# MEMORANDUM

<b>TO:</b>	Robespierre Howard Statewide Title VI Specialist & ADA Compliance Officer	<b>DATE:</b>	April 9, 2025
<b>THRU:</b>	Christina Huber, P.E. DOT&PF Project Manager Ryan Harris, P.E. DOT&PF Project Engineer	<b>TELEPHONE NO:</b>	269-0572
<b>FROM:</b>	David Gamez, P.E. PTOE Lounsbury Project Manager Jeremiah Gingrich, P.E. Lounsbury Project Engineer	<b>PROJECT NAME:</b>	Old Seward Highway: O'Malley Road to Rabbit Creek Road Pavement Preservation
		<b>PROJECT NO.:</b>	0537010/CFHWY000886
		<b>SUBJECT:</b>	<b>ADA Transition Memo</b>

Subject: Old Seward Highway: O'Malley Road to Rabbit Creek Road Pavement Preservation  
Draft Curb Ramp Recommendations Memorandum  
Project No. 0537010/CFHWY00886

PROJECT NAME: Old Seward Hwy mt Huffman PP  
 PROJECT NUMBER: CFHWY 00886 / 0537010  
 PRIMARY STREET: Old Seward Hwy  
 SECONDARY STREET: Helen Dr. SE  
 LEVEL MAKE/MODEL: Stabila Tech 196

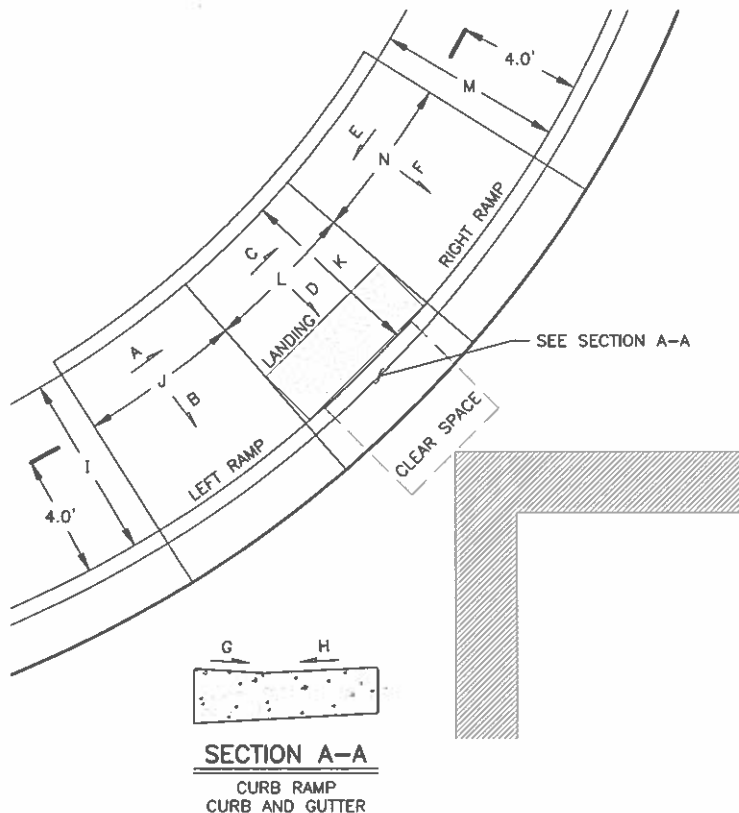
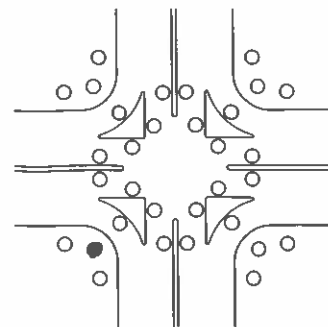
MEASURED	CR ADA STANDARD
A	7.3	8.3% MAX
B	1.1	2.0% MAX
C	0.8	2.0% MAX
D	1.2	2.0% MAX
E	6.1	8.3% MAX
F	1.3	2.0% MAX
G	7.0	8.3% MAX
H	6.8	5.0% MAX
I	102"	48" MIN
J	69.5"	15.0' MAX
K	101"	48" MIN
L	60"	60" MIN
M	102.5"	48" MIN
N	84"/7'	15.0' MAX

*Parade 11P  
crack between  
gutter*

- ☒ YES ☐ NO
- ☐ YES ☒ NO
- ☐ YES ☒ NO
- ☒ YES ☐ NO
- ☒ YES ☐ NO
- ☐ YES ☐ NO ☒ N/A
- ☒ YES ☐ NO
- ☐ YES ☐ NO ☒ N/A
- ☐ YES ☒ NO

PROJECT NAME: Old Seward Hwy and Huffman PP  
 PROJECT NUMBER: CFHWY 00886 / 0537010  
 PRIMARY STREET: Old Seward Hwy  
 SECONDARY STREET: CENTER ST SW  
 LEVEL MAKE/MODEL: Stabila Tech 196

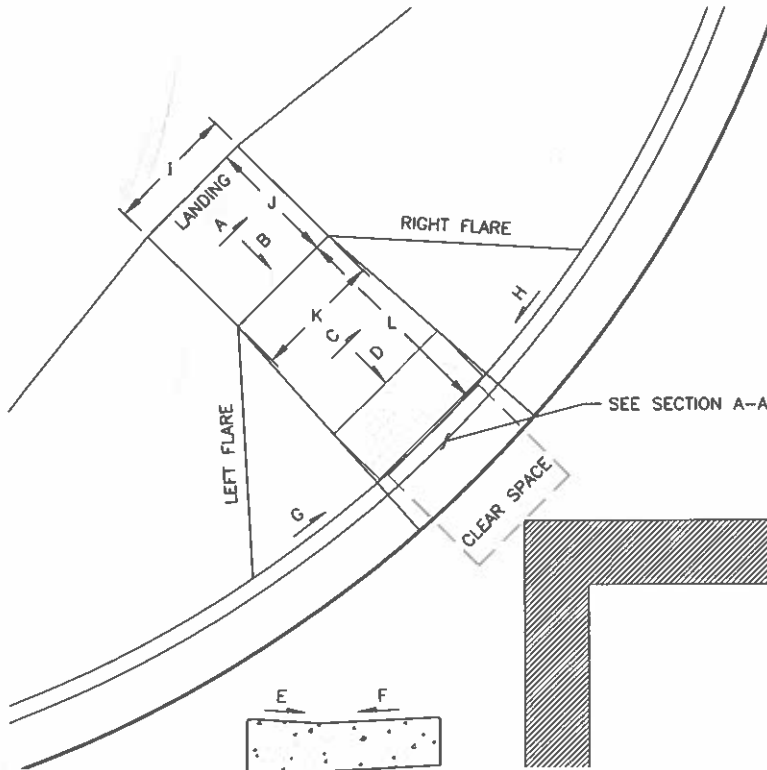
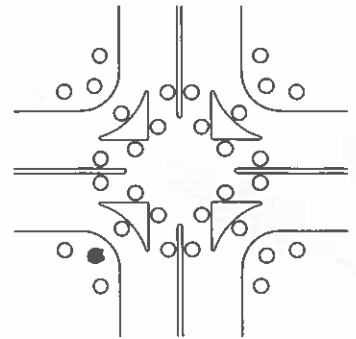
MEASURED	CR ADA STANDARD
A	7.0	8.3% MAX
B	0.9	2.0% MAX
C	1.7	2.0% MAX
D	1.5	2.0% MAX
E	2.2	8.3% MAX
F	1.5	2.0% MAX
G	4.2	8.3% MAX
H	3.6	5.0% MAX
I	117"	48" MIN
J	6' 4"	15.0' MAX
K	120"	48" MIN
L	55"	60" MIN
M	123"	48" MIN
N	64"	15.0' MAX

- ☒ YES    ☐ NO  
☒ YES    ☐ NO  
☒ YES    ☐ NO  
☒ YES    ☐ NO  
☒ YES    ☐ NO  
☐ YES    ☐ NO    ☒ N/A  
☒ YES    ☐ NO  
☒ YES    ☐ NO    ☐ N/A  
☐ YES    ☒ NO

PROJECT NAME: Old Seward Hwy and Huffman PP  
 PROJECT NUMBER: CFHWY 00886 / 0537010  
 PRIMARY STREET: Old Seward Hwy  
 SECONDARY STREET: O'MALLEY RD SE south  
 LEVEL MAKE/MODEL: Stabila Tech 196

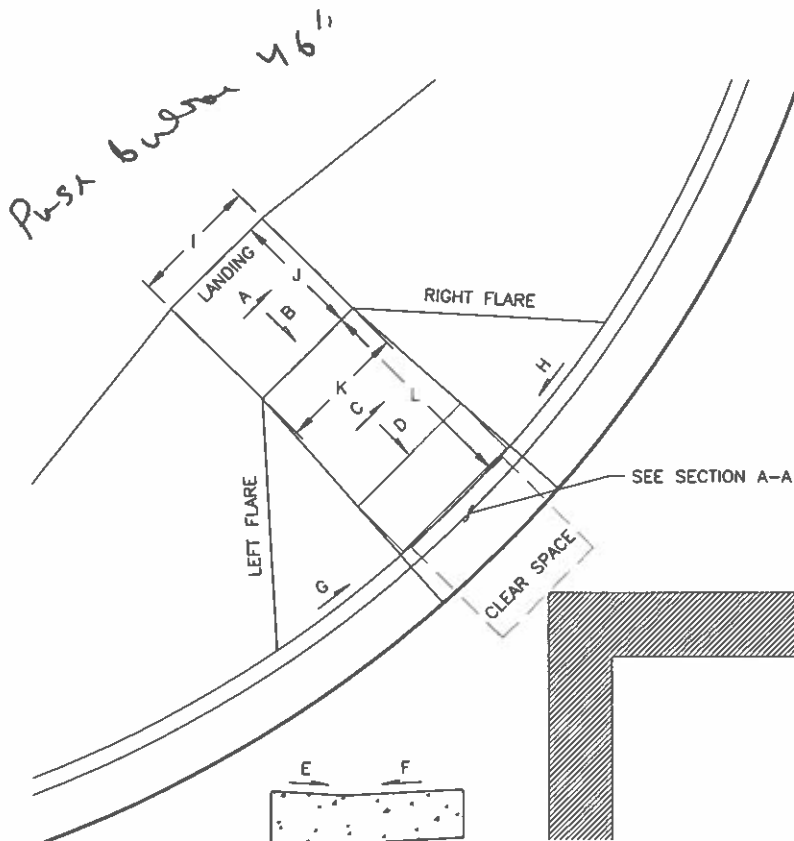
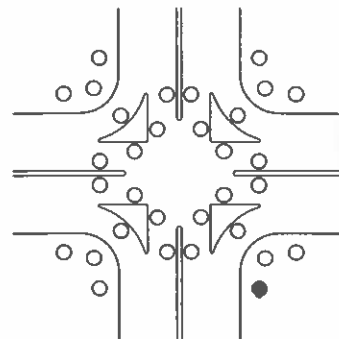
MEASURED	OR ADA STANDARD
A	1.4	2.0% MAX
B	1.0	2.0% MAX
C	1.9 <del>2.0</del>	2.0% MAX
D	4.9	8.3% MAX
E	10.7	8.3% MAX
F	7.6	5.0% MAX
G	3.0	10.0% MAX
H	6.4	10.0% MAX
I	61.5"	36" MIN
J	60"	36" MIN
K	61.5"	36" MIN
L	6'	15.0' MAX

ASHPW 11P

PROJECT NAME: Old Seward Hwy and Huffman PP  
 PROJECT NUMBER: CFHWY 00886 / 0537010  
 PRIMARY STREET: Old Seward Hwy  
 SECONDARY STREET: O'MALLEY RD SE north  
 LEVEL MAKE/MODEL: STABILA TECH 196

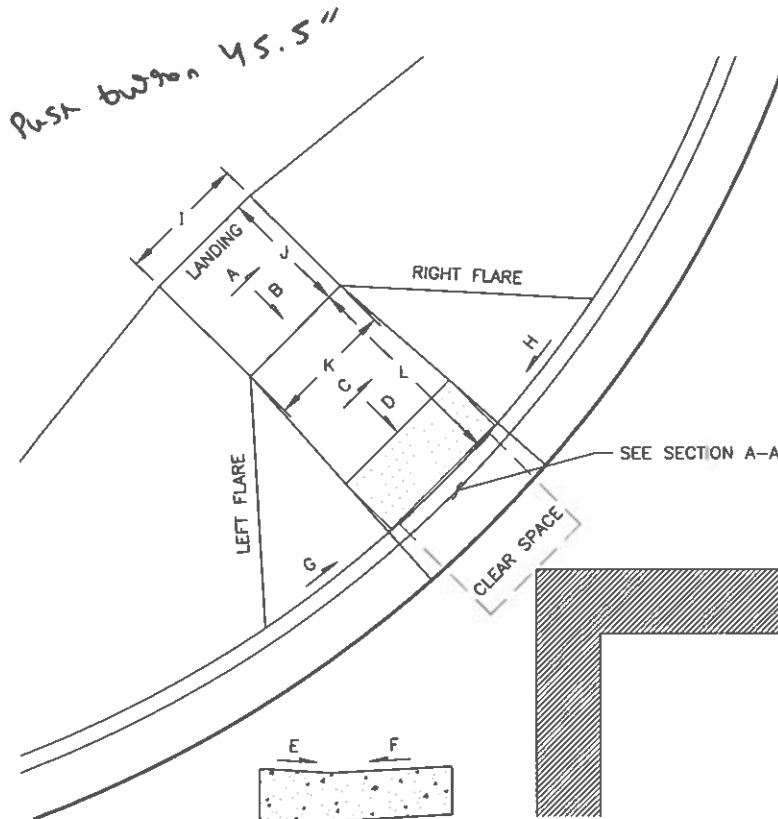
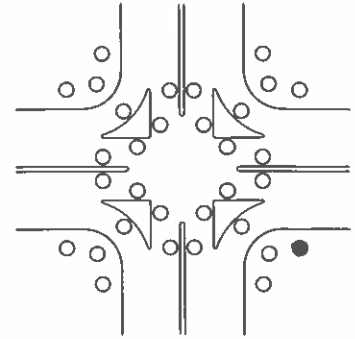
MEASURED	CR ADA STANDARD
A	6.4	2.0% MAX
B	1.4	2.0% MAX
C	0.8	2.0% MAX
D	6.1	8.3% MAX
E	12.4	8.3% MAX
F	5.0	5.0% MAX
G	2.5	10.0% MAX
H	6.2	10.0% MAX
I	60"	36" MIN
J	48"	36" MIN
K	60"	36" MIN
L	52"	15.0' MAX

*LIP on Pavement and detectable warning tile*
